Amendments to the Drawings:

REMARKS/ARGUMENTS

FIG. 1

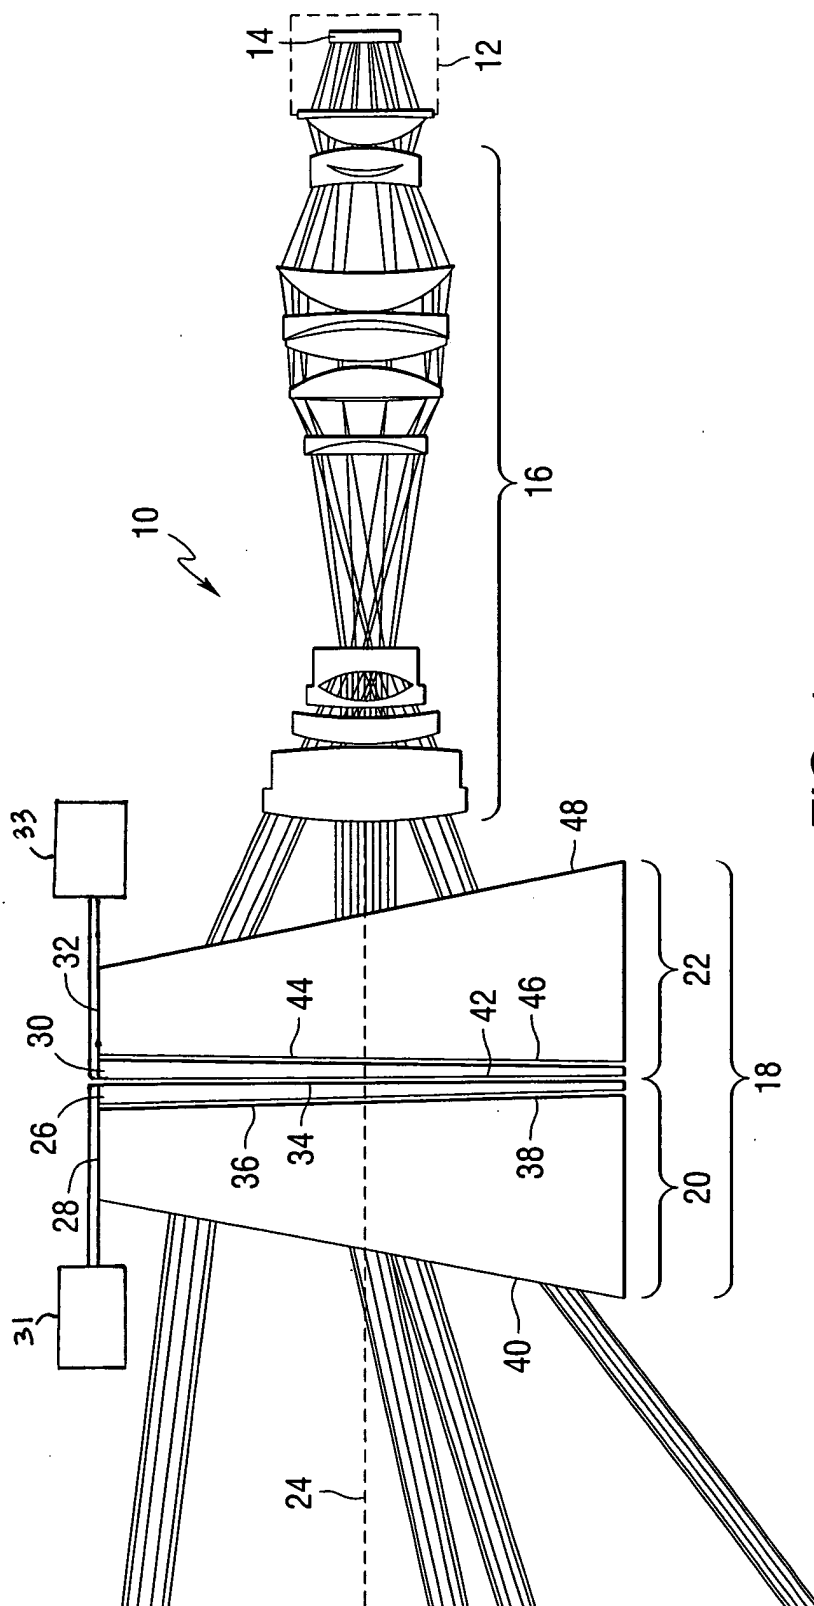
FIG. 1 has been amended to include motors 31 and 33. FIGs. 2 and 4 have been amended to identify materials. FIGs. 3 and 5 have been amended to include specific angle values. The attached replacement sheets, which include FIGs. 1-5, replace the original sheets that included FIGs. 1-5.

In Section 4 of the Detailed Action portion of the Office Action, the drawings have been objected to under 37 CFR 1.83(a) for failure to show every feature of the invention specified in the claims. This objection has been addressed in the enclosed substitute drawing sheets where the at least one motor of claim 1; the zinc-sulfide prism of claims 3, 4, 11 and 12; the sapphire prism of claims 3 and 11; the germanium prism of claims 4 and 12; and the angles 88.632° and 100.624° of claims 5 and 13 are now shown in the amended drawings.
